## 10.4 Other Features of Steam and Power Conversion

The information in this section of the reference ABWR DCD, including all subsections, tables, and figures is incorporated by reference with the following departures and supplements.

Figure 10.4-1 Main Condenser Evacuation System

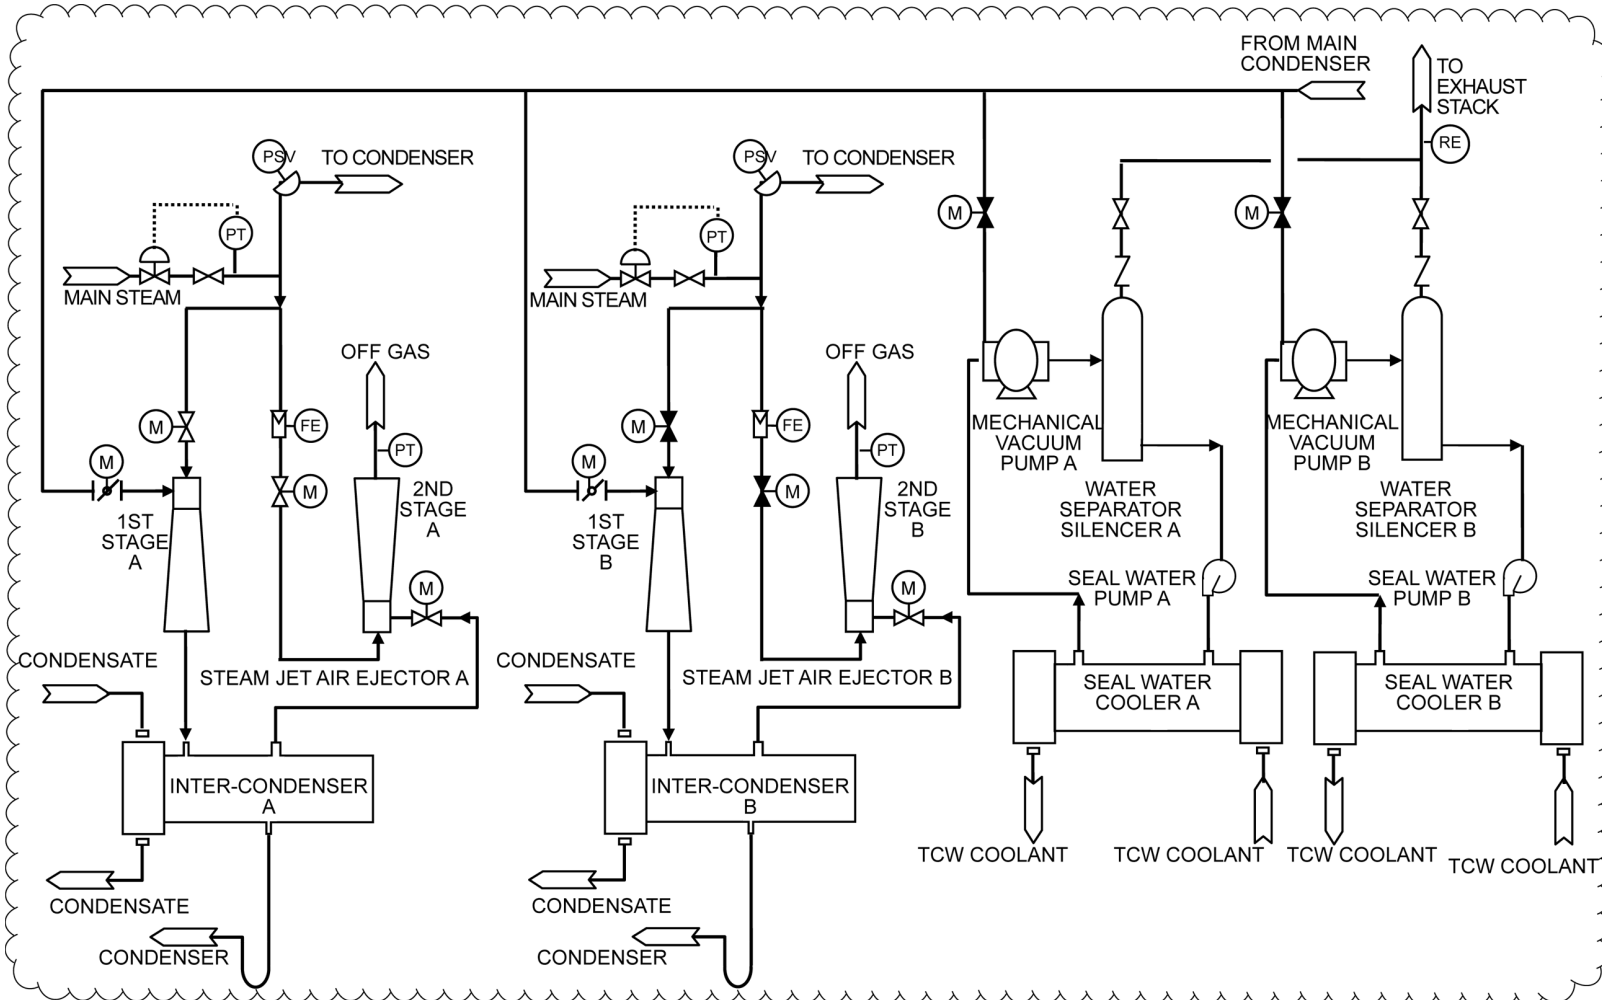
STP DEP 10.4-3 (Table 10.4-2, Figure 10.4-1)

The MCES (figure 10.4-1) consists of two 100%-capacity, double stage, steam jet air ejector (SJAE) units (complete with ~~intercondenser~~ intercondensers) for power plant operation, and a two, 100% mechanical vacuum pump pumps for use during startup. The last stage of the SJAE is a noncondensing stage. One SJAE unit is normally in operation and the other is on standby.

The SJAEs are placed in service to remove the gases from the main condenser after a pressure of about ~~0.034 to 0.051 MPa~~ 7kPa absolute or less is established in the main condenser by the mechanical vacuum pumps and when sufficient nuclear steam pressure is available.

Figure 10.4-2 Turbine Gland Seal System

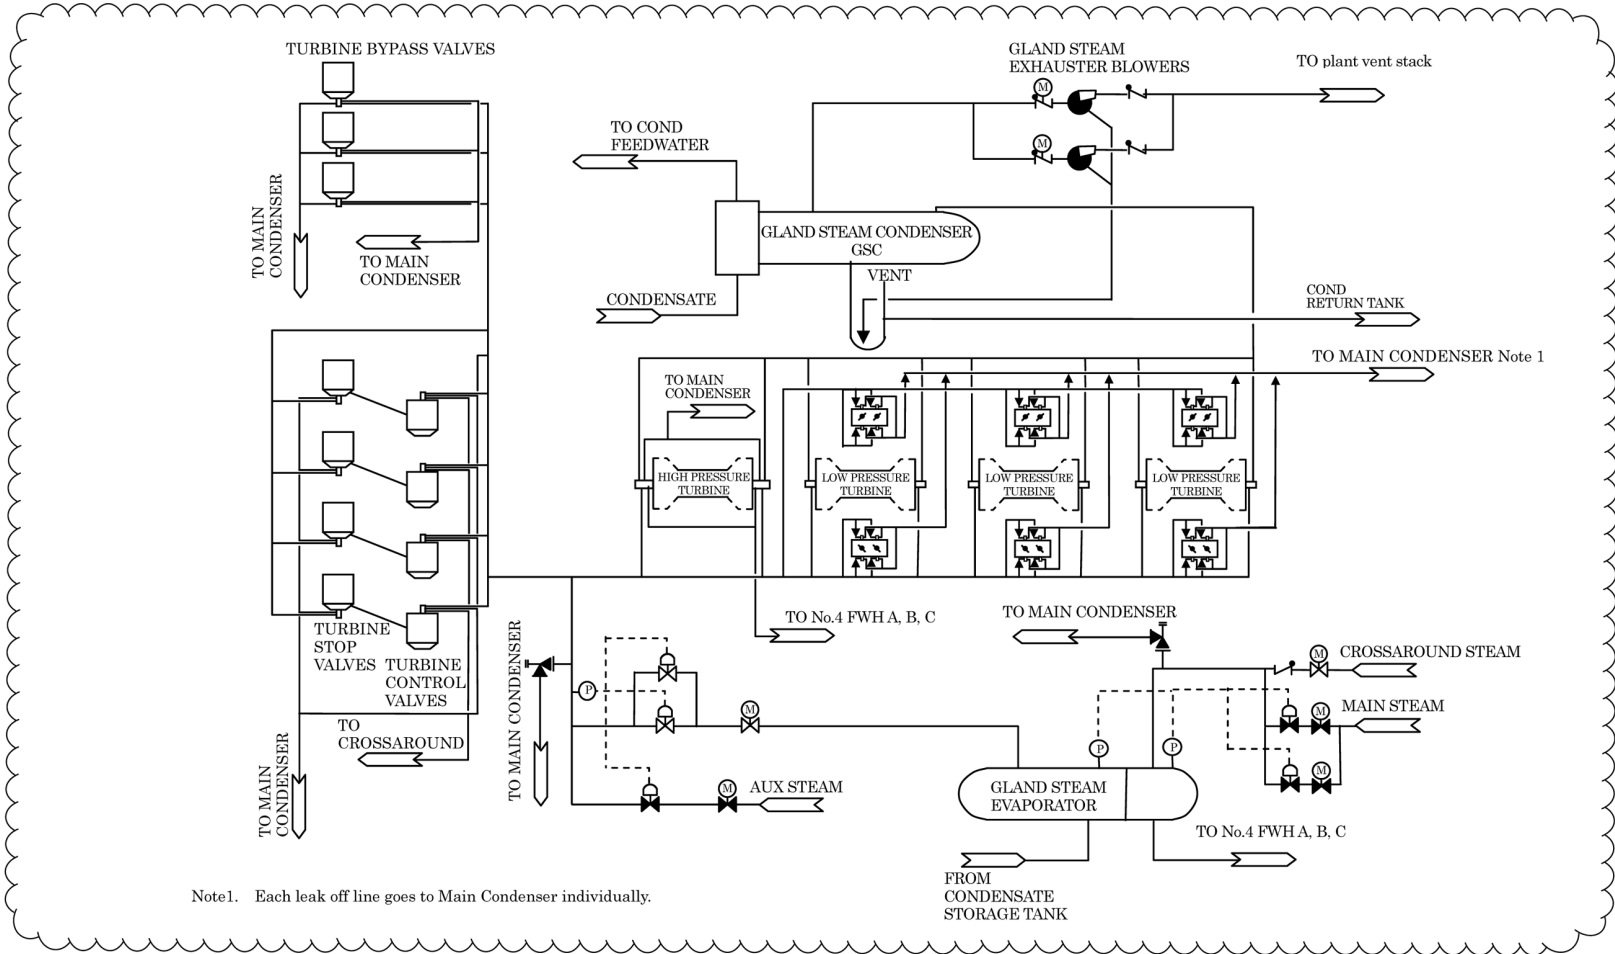
STD DEP 10.4-1 (Figure 10.4-2)

~~The turbine gland seal system is illustrated in Figure 10.4-2. The turbine gland seal system consists of a gland steam evaporator, sealing steam pressure regulator, sealing steam header, a gland steam condenser with two full-capacity exhausters blowers, and the associated piping, valves and instrumentation.~~

Figure 10.4-3 Circulating Water System

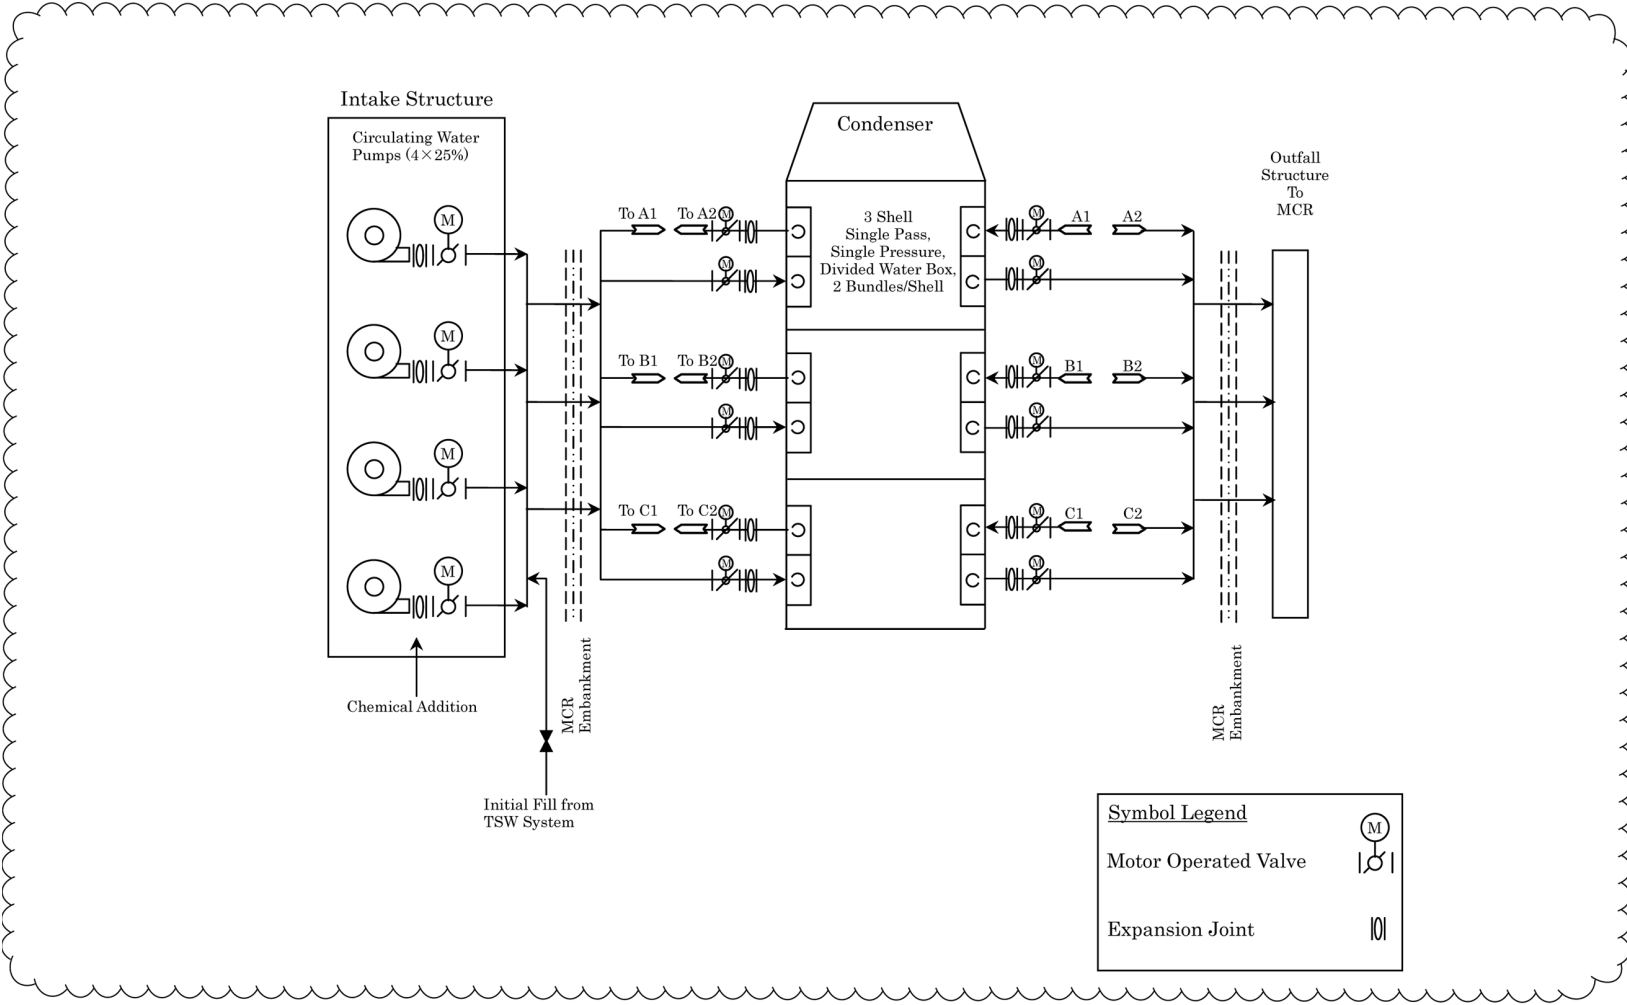
STP DEP 10.4-2 (Table 10.4-1, Table 10.4-3, Figure 10.4-3)

*~~The three condenser shells are designated as the low pressure shell, the intermediate pressure shell, and the high pressure shell. The three condenser shells are cross-connected to equalize pressure. Each shell has at least two tube bundles. Circulating water flows in series parallel through the three single-pass shells (Figure 10.4-3).~~*

*The Circulating Water System (Figure 10.4-3) consists of the following components: (1) ~~screen house intake structure and intake screens,~~ pumps, (2) condenser water boxes and piping and valves, (3) tube side of the main condenser, (4) water box fill and drain subsystem, and (5) related support facilities such as for system water treatment, inventory blowdown and general maintenance.*

Four 25% capacity fixed speed circulating water pumps per unit discharge into a common header shown in Figure 10.4-3. The discharge of each pump is fitted with a motor operated butterfly valve. The circulating water is pumped through the main condenser and back to the MCR via a discharge outfall at a nominal rate of 272,550 m<sup>3</sup>/h per unit. To provide capability for condenser waterbox isolation, isolation valves are located on the circulating water inlet and outlet lines.

Figure 10.4-5 Condensate System

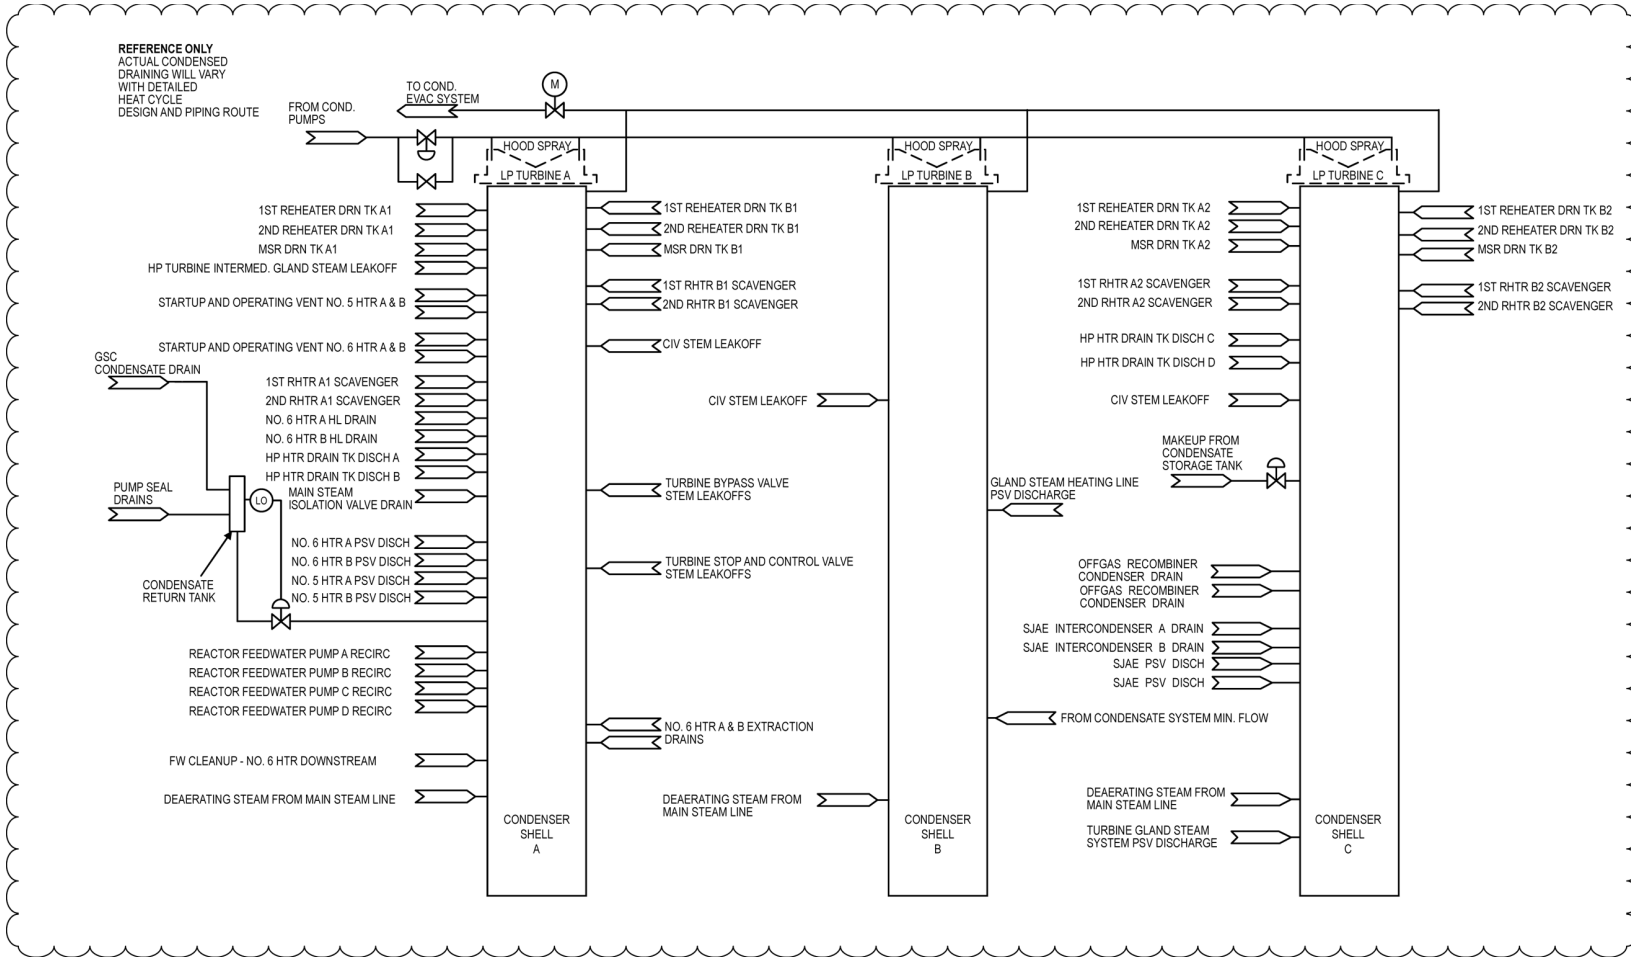
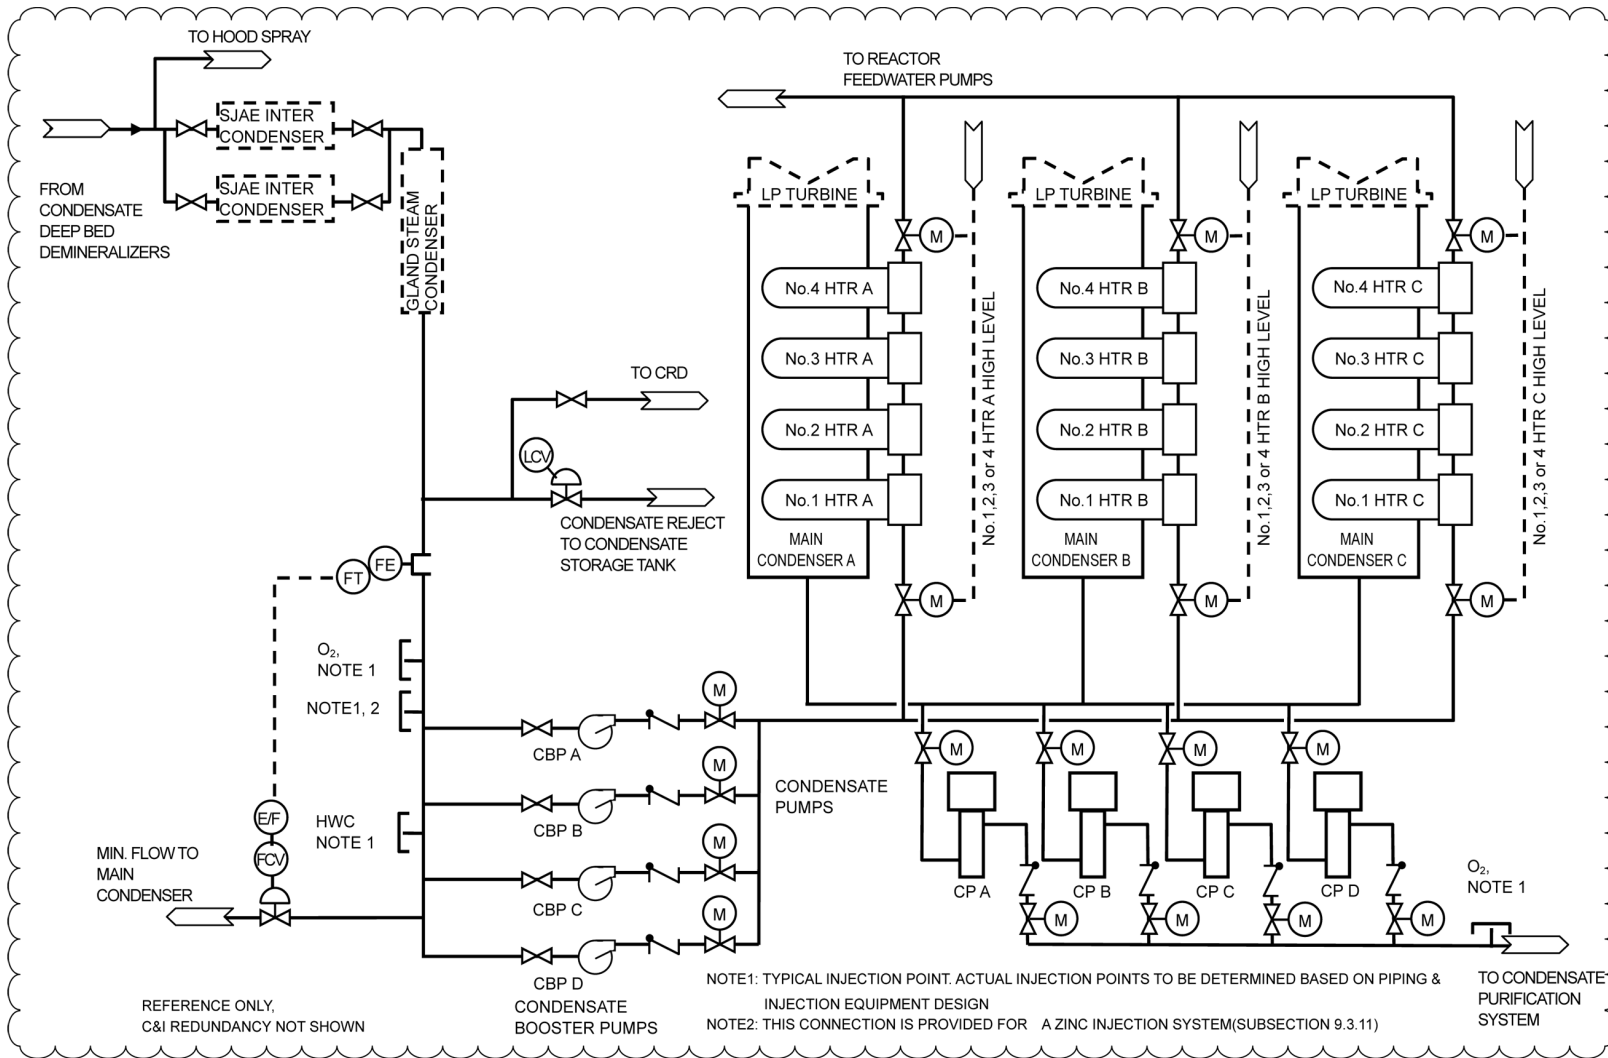
STD DEP 9.2-3 (Figure 10.4-5)

STD DEP 10.4-5 (Tables 10.4-4, 10.4-5 and 10.4-6, Figures 10.4-5, 10.4-6, 10.4-7, and 10.4-8)

*The Condensate and Feedwater System (Figures 10.4-5 and 10.4-6) consists of the piping, valves, pumps, heat exchangers, controls and instrumentation, and the associated equipment and subsystems which supply the reactor with heated feedwater in a closed steam cycle utilizing regenerative feedwater heating. The system described in this subsection extends from the main condenser outlet to (but not including) the seismic interface restraint outside of containment. The remainder of the system, extending from the restraint to the reactor, is described in Chapter 5. Turbine cycle steam is utilized for a total of six stages of closed feedwater heating. The drains from each stage of the low-pressure feedwater heaters are cascaded through successively lower pressure feedwater heaters except the lowest and second lowest pressure feedwater heaters which drain to the low pressure heater drain tanks for each string. The drains from each low pressure heater drain tank flow into the external drain coolers of each lowest pressure feedwater heater and finally to the main condenser. The high pressure heater drains are pumped backward to the reactor feedwater pumps suction. The cycle extraction steam, drains and vents systems are illustrated in Figures 10.4-7 and 10.4-8.*

Figure 10.4-9 Bypass Valve Control, Electro-Hydraulic Control Unit

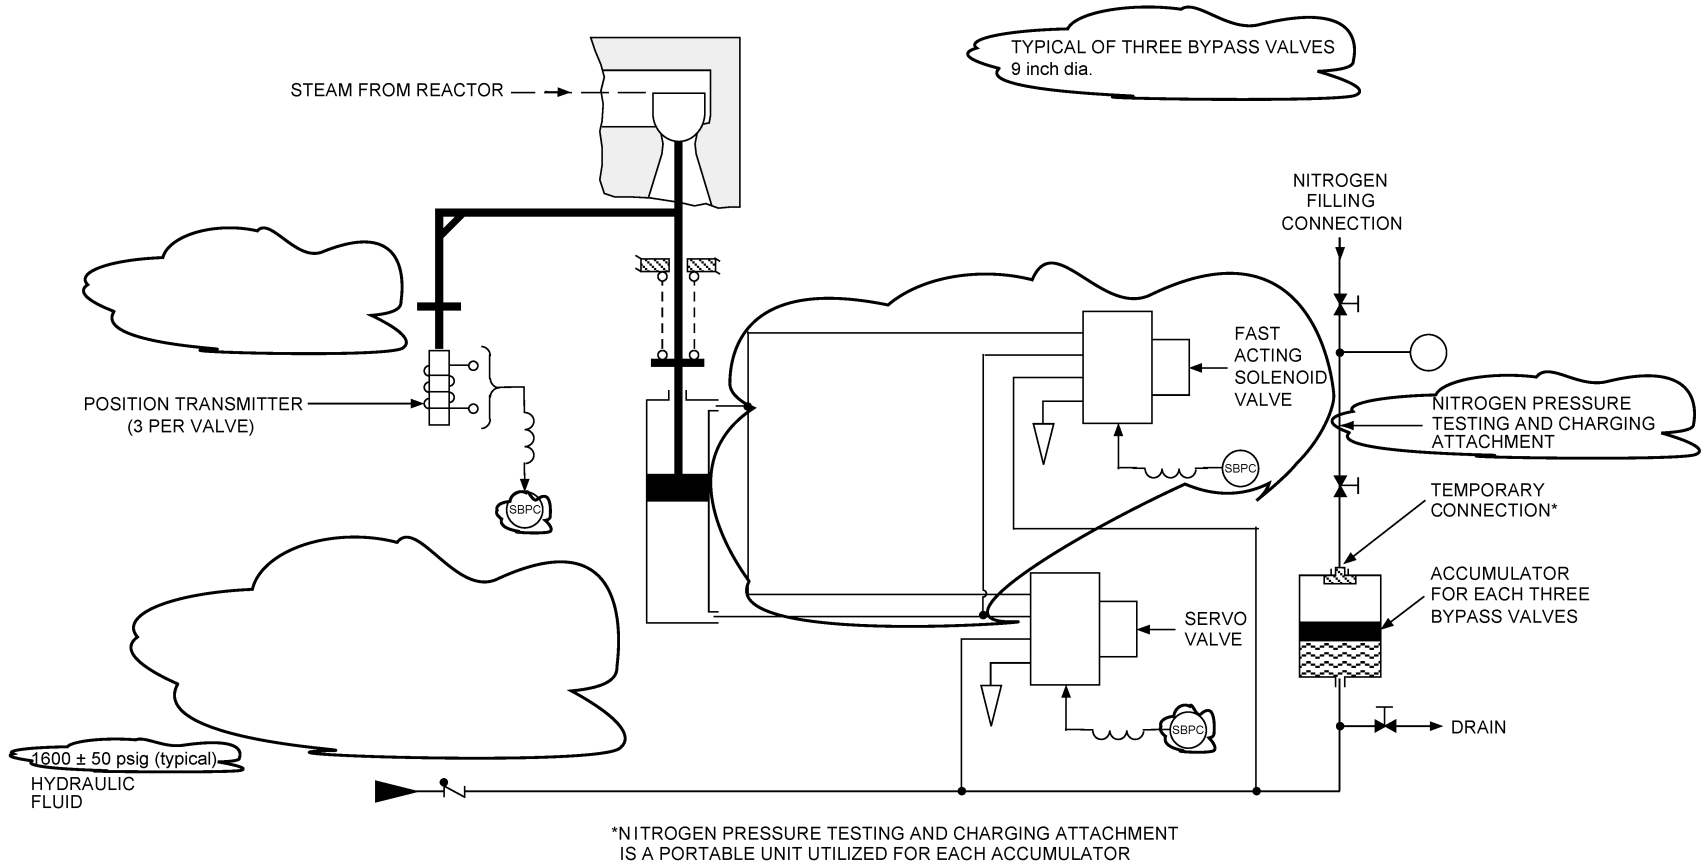
STD DEP 10.4-7 (Figure 10.4-9)
